PROPOSED RESIDENTIAL DEVELOPMENT

8330 SECTION 4.55 SUBMISSION 38 CUDGEGONG RD ROUSE HILL, NSW 2155

PROPOSED RESIDENTIAL DEVELOPMENT 38 CUDGEGONG RD ROUSE HILL, NSW 2155 L.G.A : BLACKTOWN CITY COUNCIL

SHEET TITLE: GROUND FLOOR PLAN OVERALL | : 300 @ A1 sheet scale 8330 DAOO4 DRAWING No.

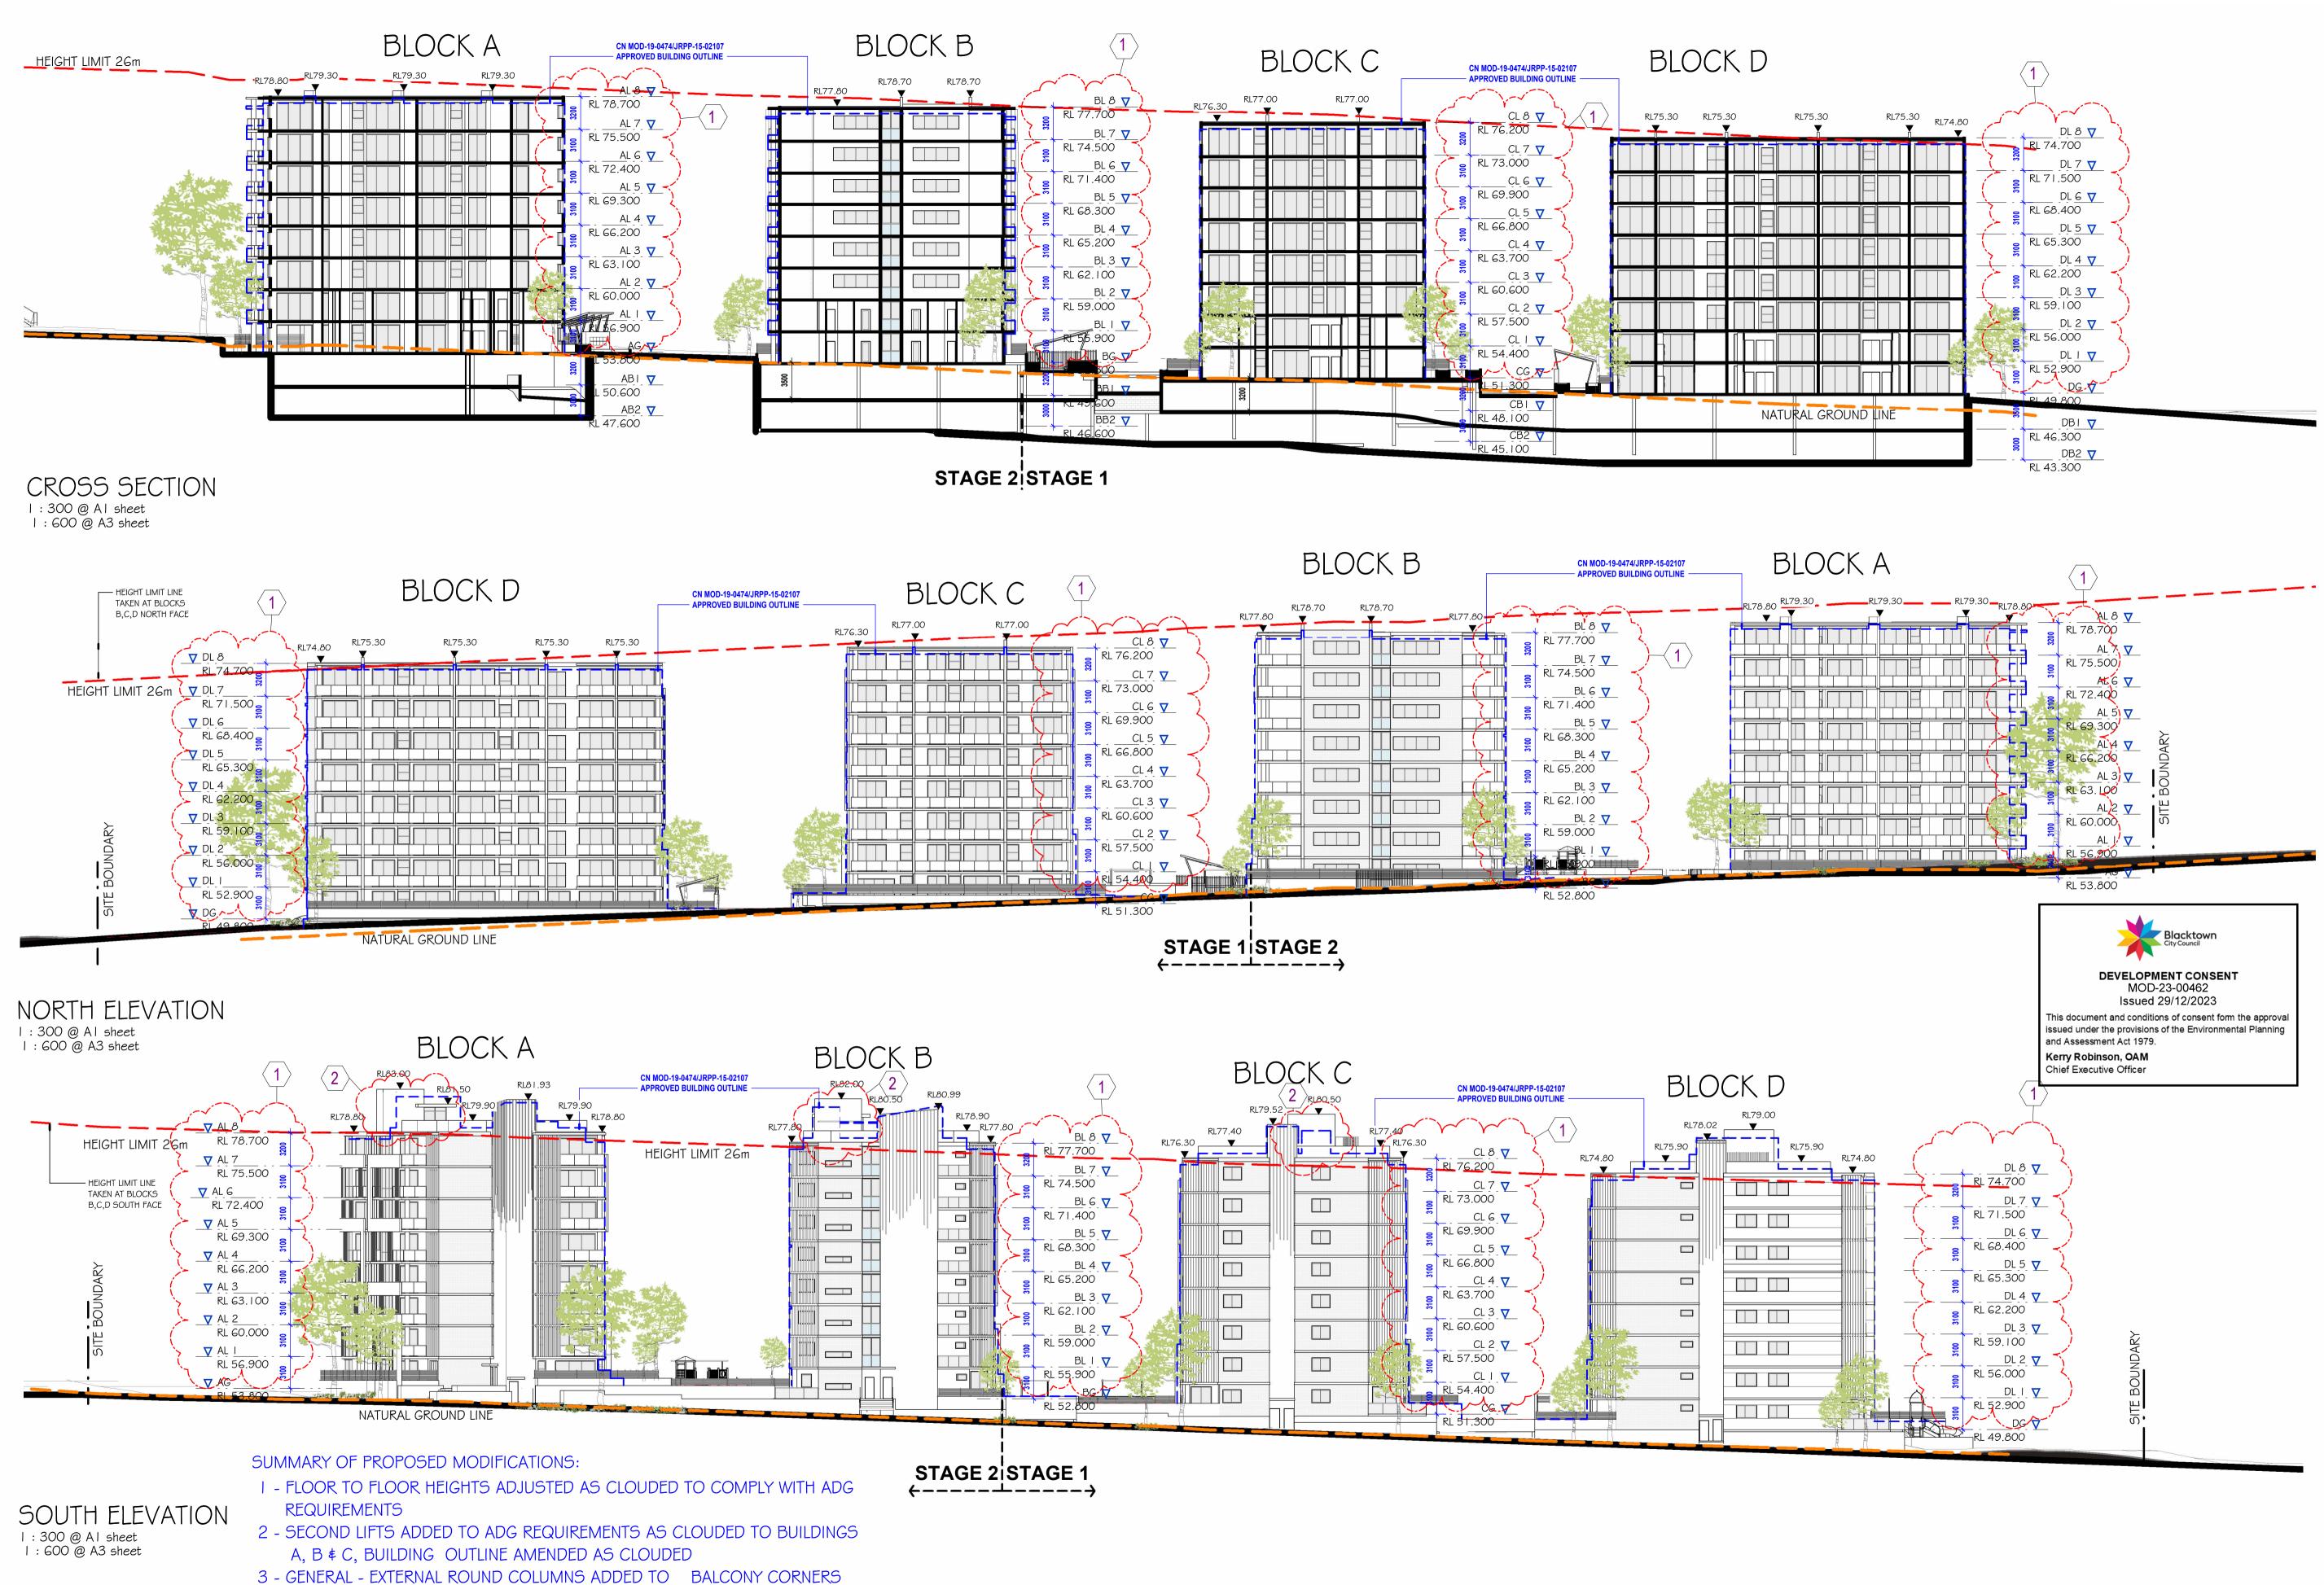
- 2 SERVICE SHAFT REMOVED AND TERRACE OUTLINE ADJUSTED
- 3 OUTLINE OF TERRACE ADJUSTED
- 4 GENERAL EXTERNAL ROUND COLUMNS ADDED TO BALCONY CORNERS

I - SECOND LIFT ADDED TO ADG REQUIREMENTS AS CLOUDED IN BUILDINGS A, B & C, BUILDING OUTLINE AMENDED AS CLOUDED

| AB - GR | OUND FLOOR | |
|---------------------------|----------------------|---|
| 8330 ^{ов No.} | DAIO3 DRAWING No. | I |

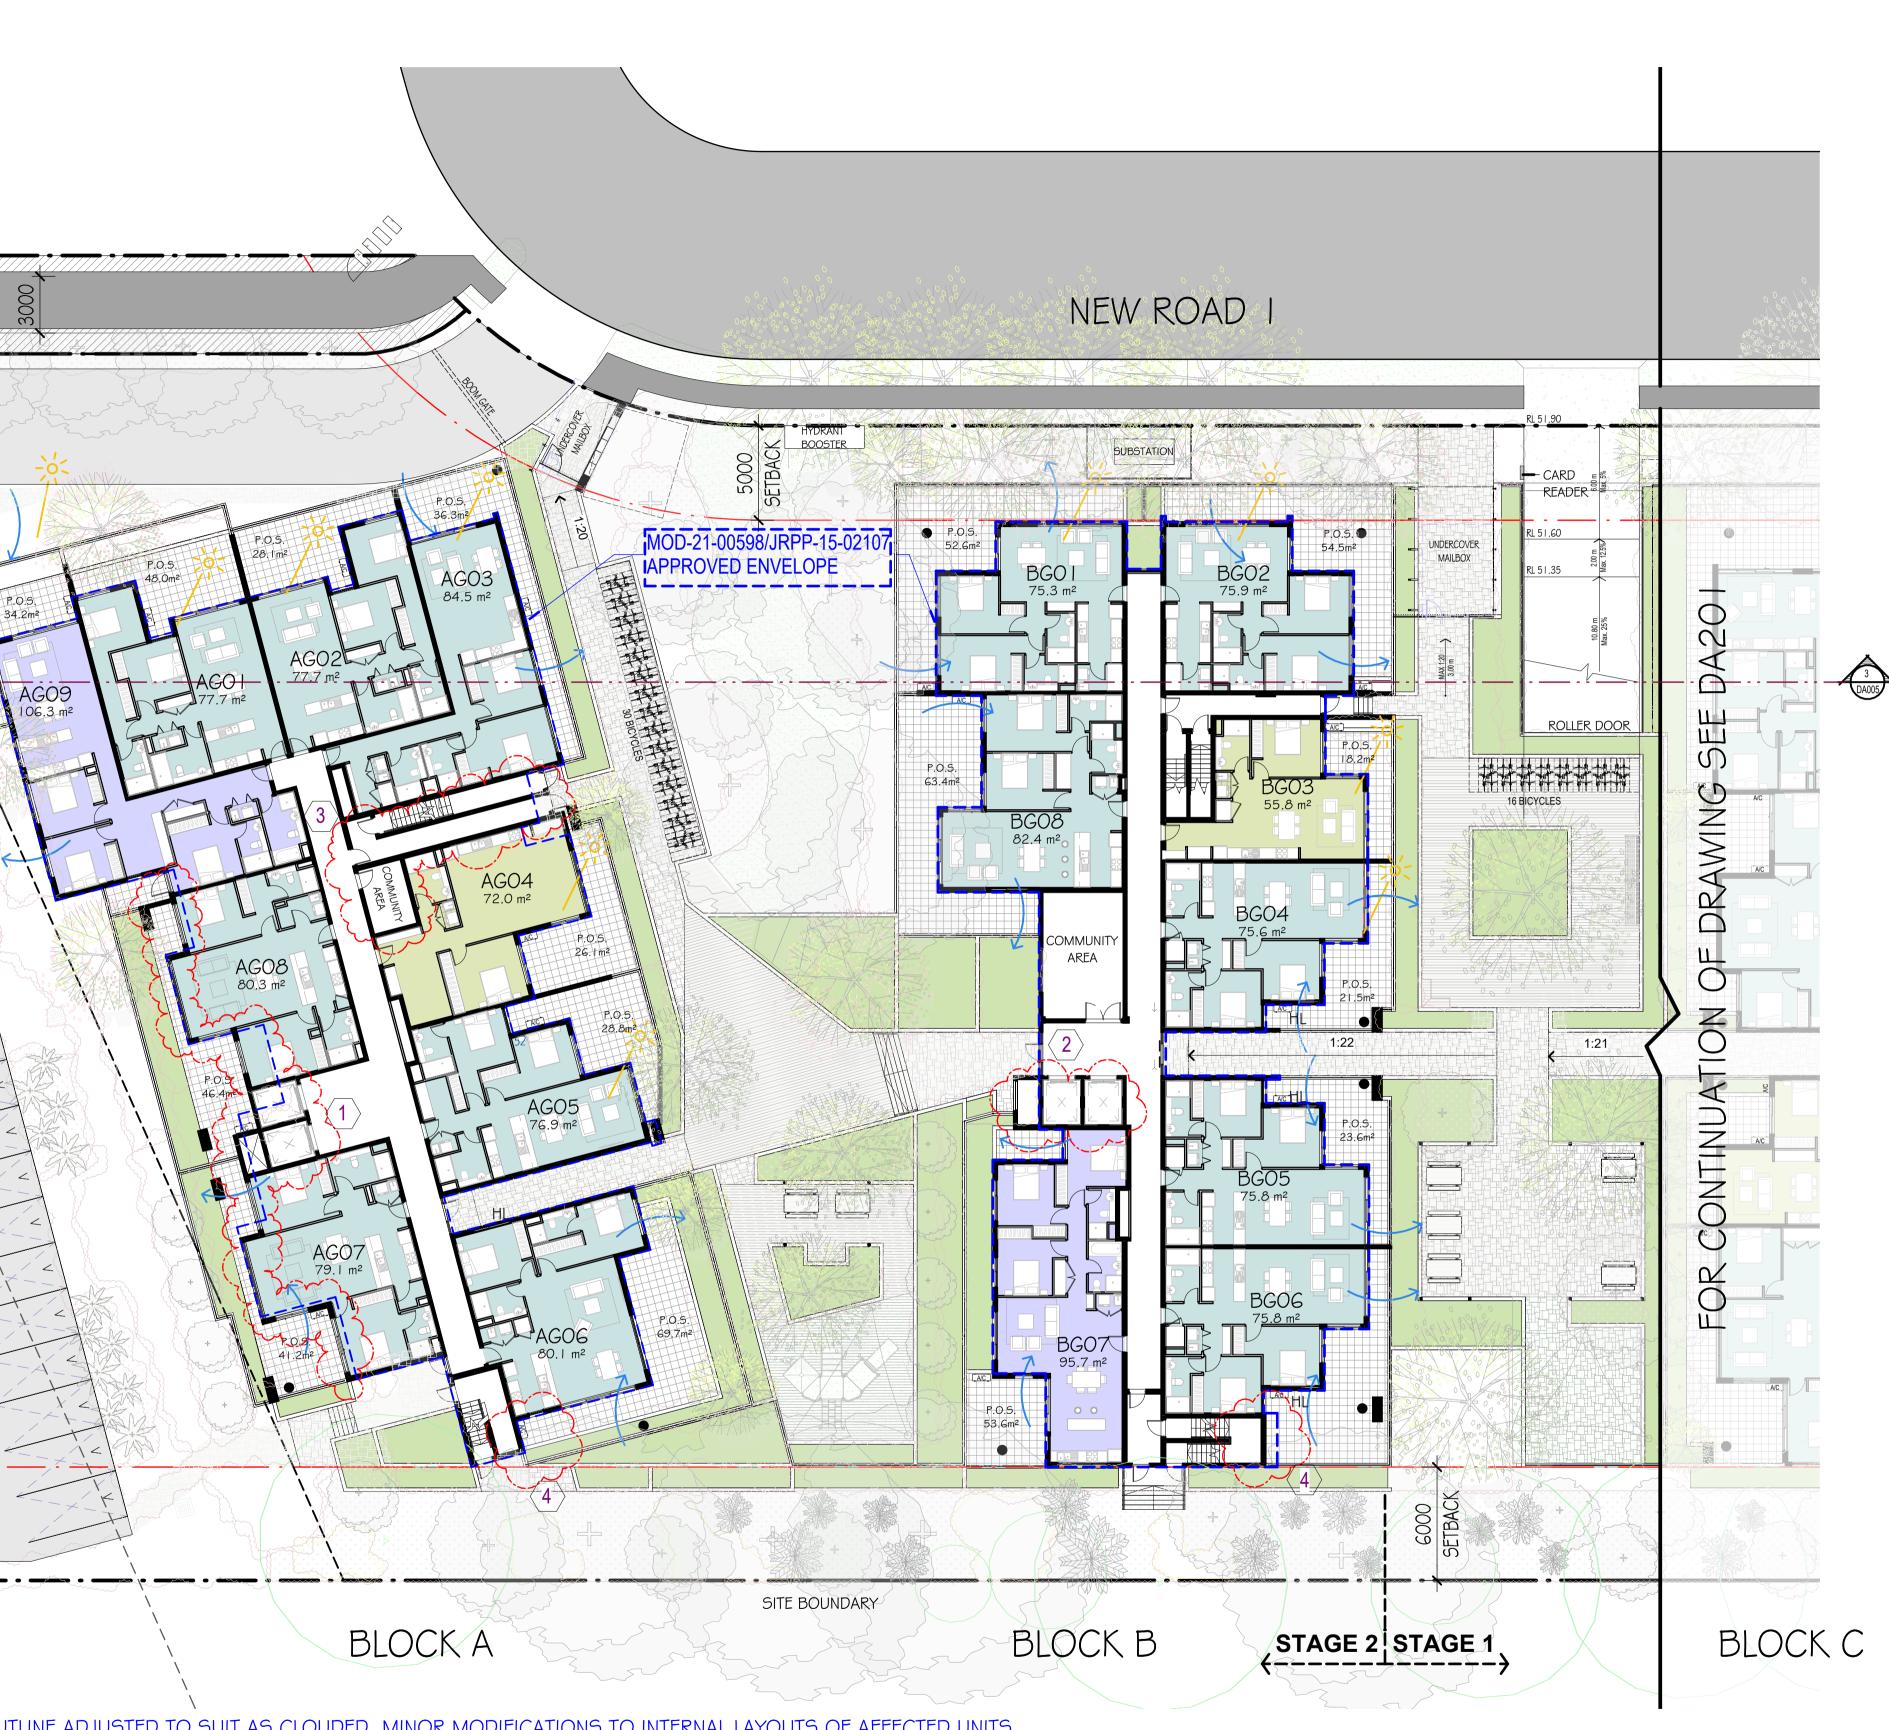
I - SECOND LIFT ADDED TO ADG REQUIREMENTS & BUILDING OUTLINE ADJUSTED TO SUIT AS CLOUDED, MINOR MODIFICATIONS TO INTERNAL LAYOUTS OF AFFECTED UNITS

3 - STAIR REDESIGNED & COMMUNITY AREA RELOCATED TO MATCH APPROVED GROUND FLOOR LAYOUTS AS PER MOD-21-00598/JRPP-15-02107

6 - GENERAL - MINOR ADJUSTMENTS TO INTERNAL APARTMENT LAYOUTS TO MATCH APPROVED GROUND FLOOR LAYOUTS AS PER MOD-21-00598/JRPP-15-02107

| sheet title: AB - FLC | OOR PLAN | I LEVEL |
|------------------------------------|----------------------|---------|
| 8330 | DAIO4 DRAWING No. | ISSL |

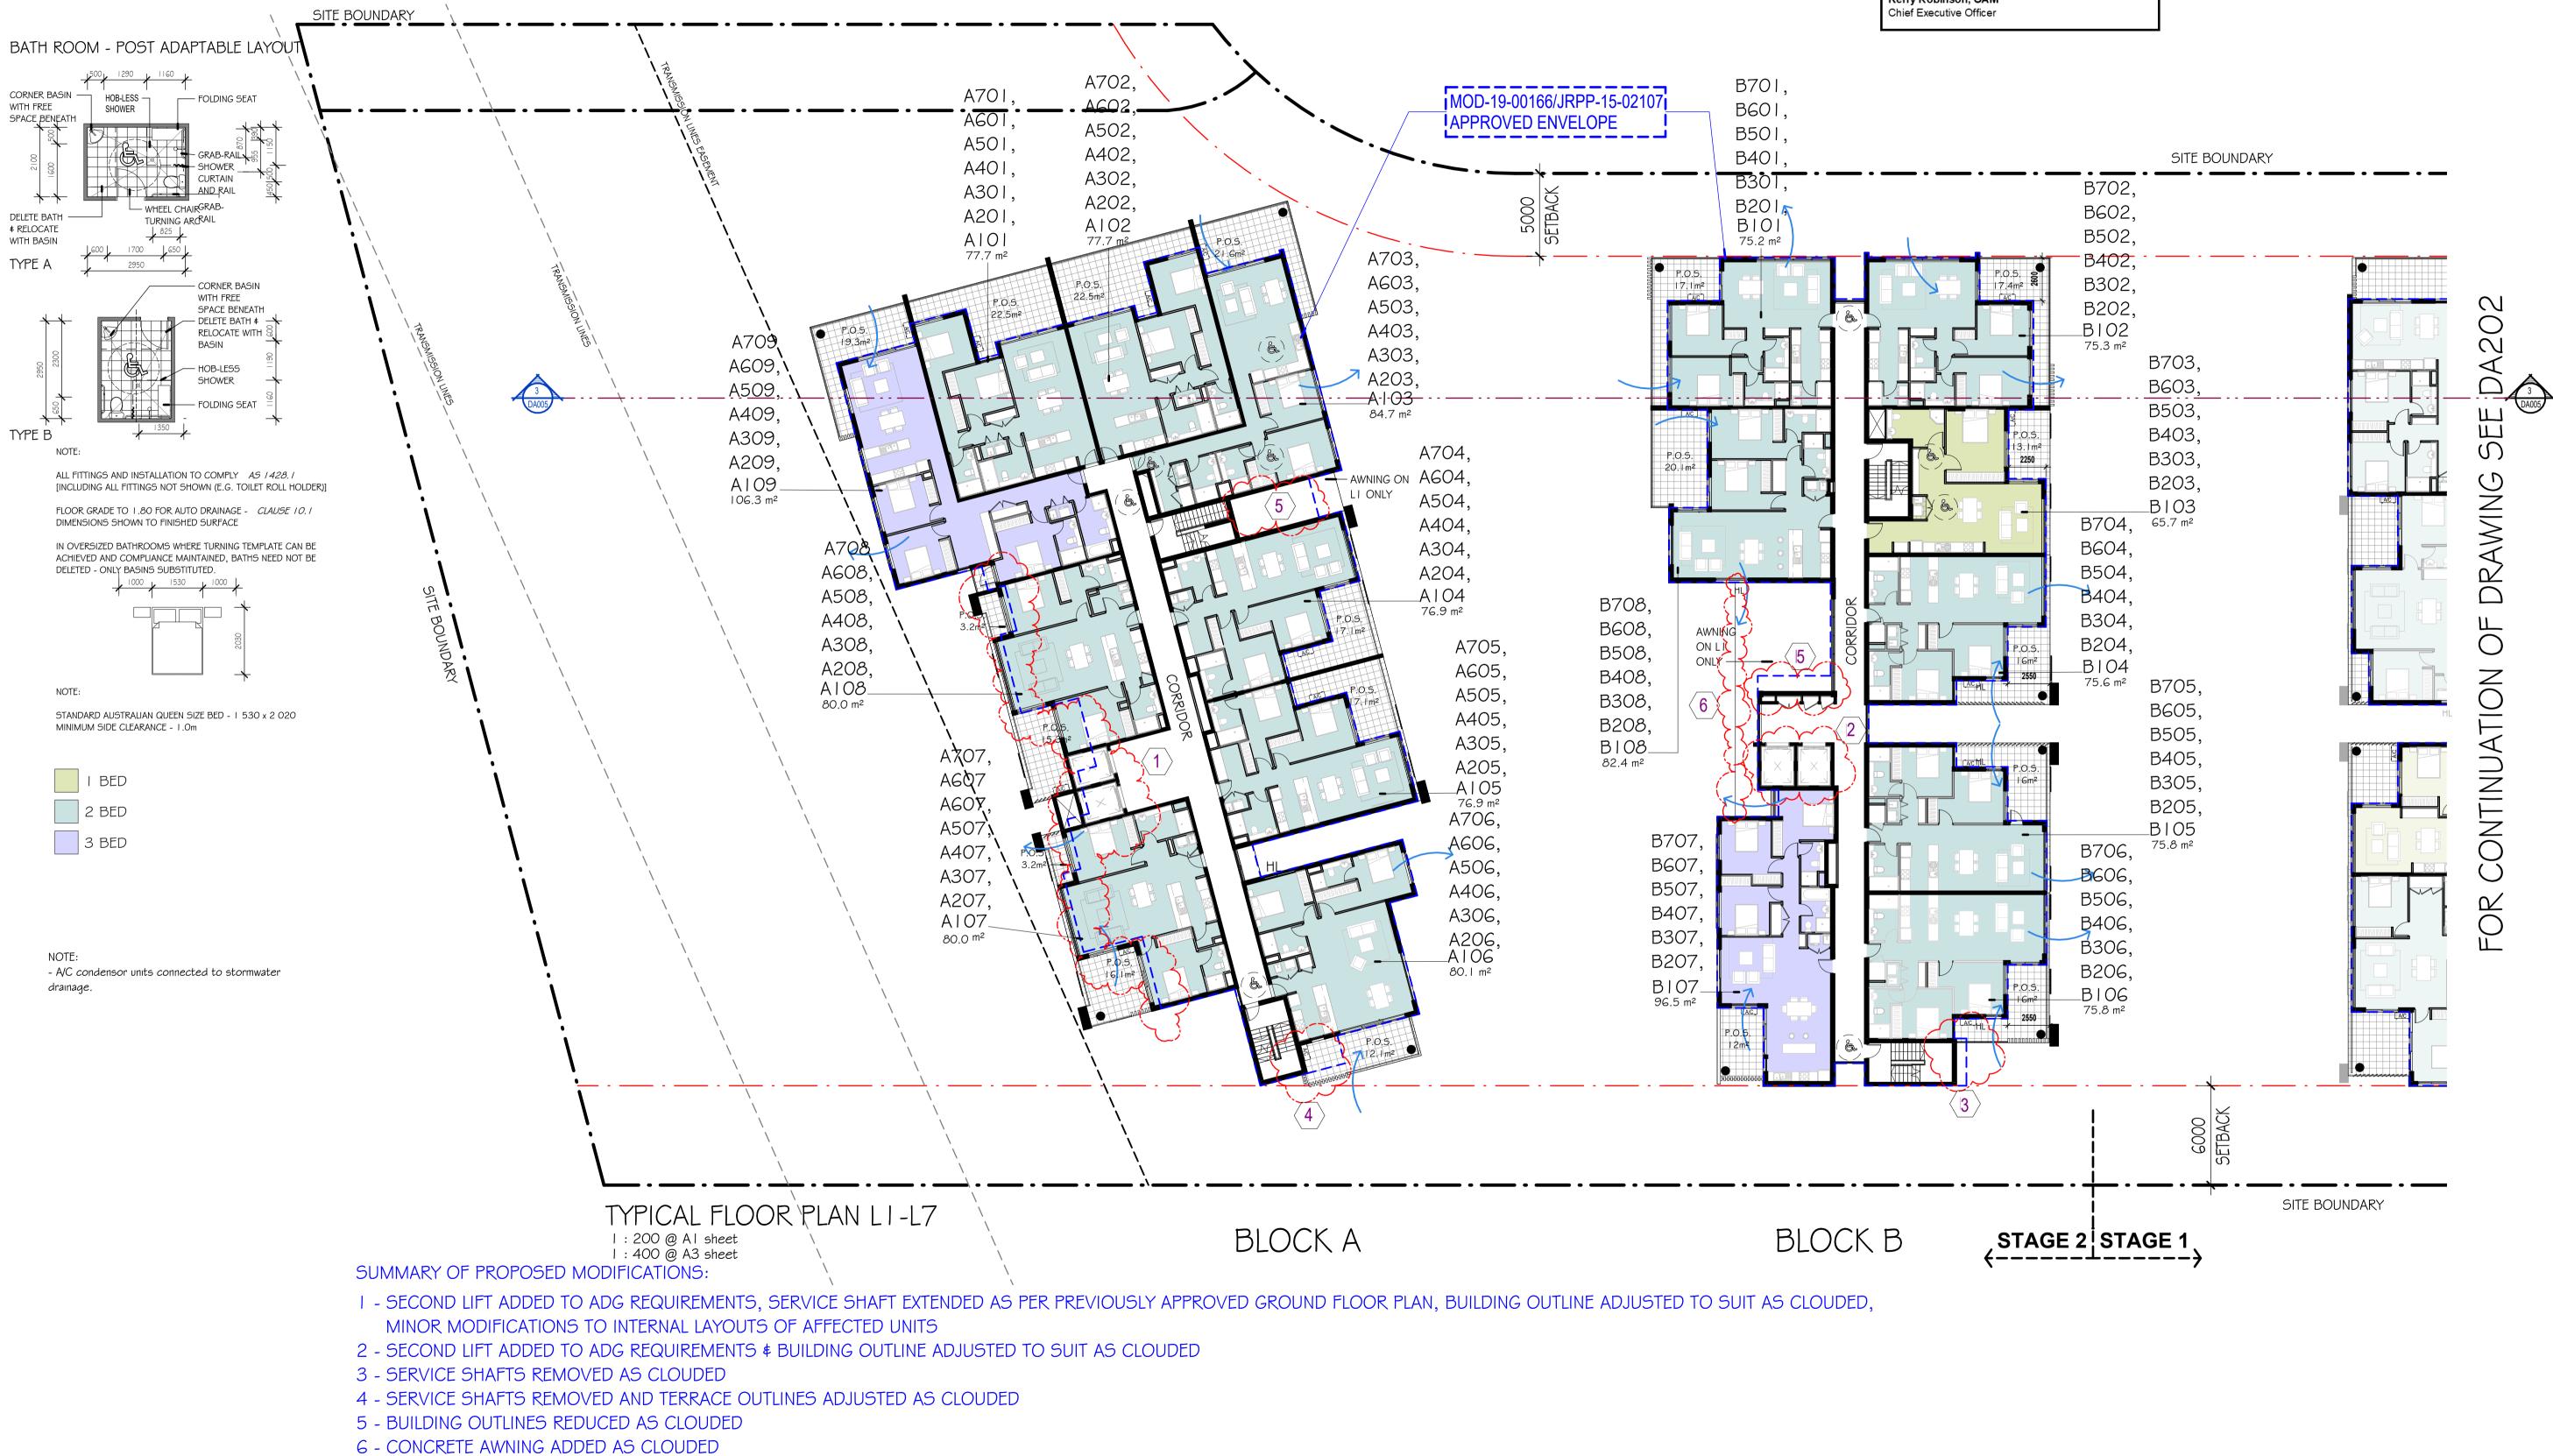
8 - GENERAL - EXTERNAL ROUND COLUMNS ADDED TO BALCONY CORNERS

7 - GENERAL - MINOR ADJUSTMENTS TO INTERNAL APARTMENT LAYOUTS TO MATCH APPROVED GROUND FLOOR LAYOUTS AS PER MOD-21-00598/JRPP-15-02107
